Title - Sujet Fit up GOCB	
Solicitation No. - N° de l'invitation EV385-173119/A	Amendment No. - N° modif. 002
Client Reference No. - N° de référence du client PWGSC EV385-173119	Date 2017-05-10
GETS Reference No. - N° de référence de SEAG PW-\$PWU-066-11068	
File No. - N° de dossier PWU-7-40010 (066)	CCC No./N° CCC - FMS No./N° VME
Solicitation Closes - L'invitation prend fin at - à 02:00 PM on - le 2017-05-18	
Time Zone Fuseau horaire Mountain Daylight Saving Time MDT	
F.O.B. - F.A.B. Plant-Usine: <input type="checkbox"/> Destination: <input type="checkbox"/> Other-Autre: <input type="checkbox"/>	
Address Enquiries to: - Adresser toutes questions à: Lee, Mony	Buyer Id - Id de l'acheteur pwu066
Telephone No. - N° de téléphone (780) 224-6675 ()	FAX No. - N° de FAX (780) 497-3510
Destination - of Goods, Services, and Construction: Destination - des biens, services et construction:

1.1 ADDENDUM FORM

This Addendum forms part of the Contract Documents and modifies the Bidding Documents dated February 17th, 2017, with amendments and additions noted below.

Project R.075025.004 – PTSS Floor Plan

ACCESS CONTROL – ELEVATION OF SINGLE DOOR WITH DOOR CONTACT, FRAME MOUNTED READER AND ELECTRIC STRIKE

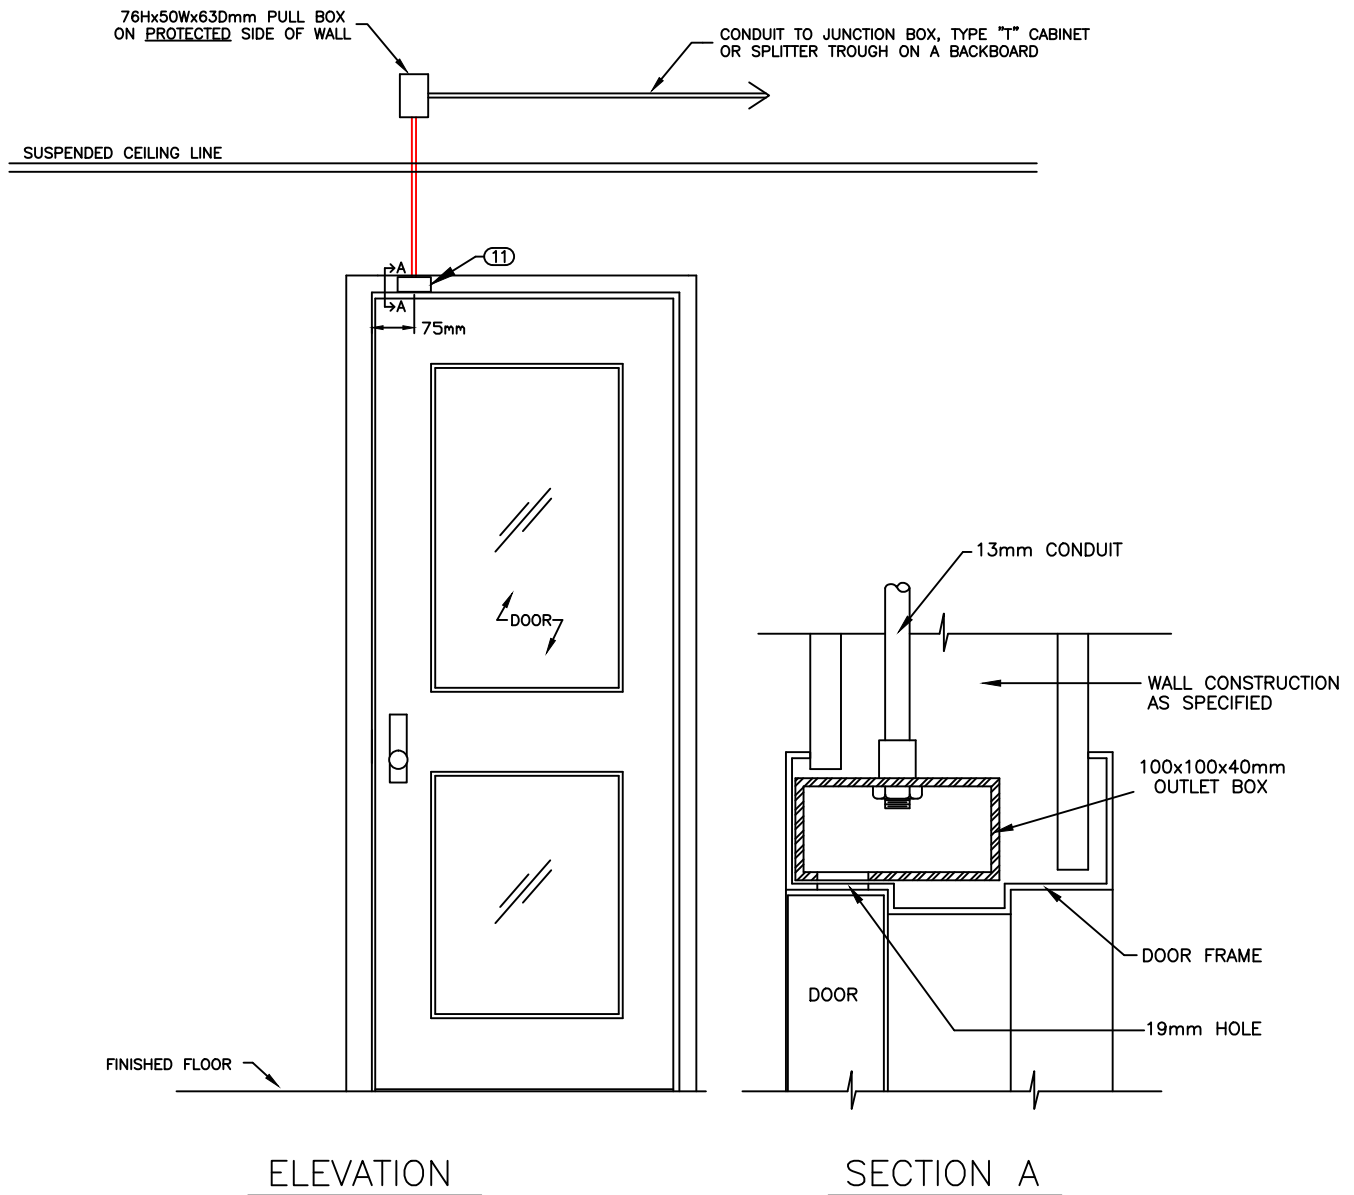
- .1 Drawing 3/A3: **REVISE** conduit system for the security system devices to match the attached documents.

CONDUIT CONNECTOR TO BE MOUNTED AND FASTENED TO OUTLET BOX BY DOOR FRAME FABRICATOR.

OUTLET BOX TO BE SPOT WELDED IN PLACE BY DOOR FRAME FABRICATOR.

DRILL A 19MM HOLE AT 75MM (CENTER POINT) FROM THE EDGE OF THE DOOR CASING TO ALLOW FOR DOOR SWITCH INSTALLATION AND ACCESS TO WIRING.
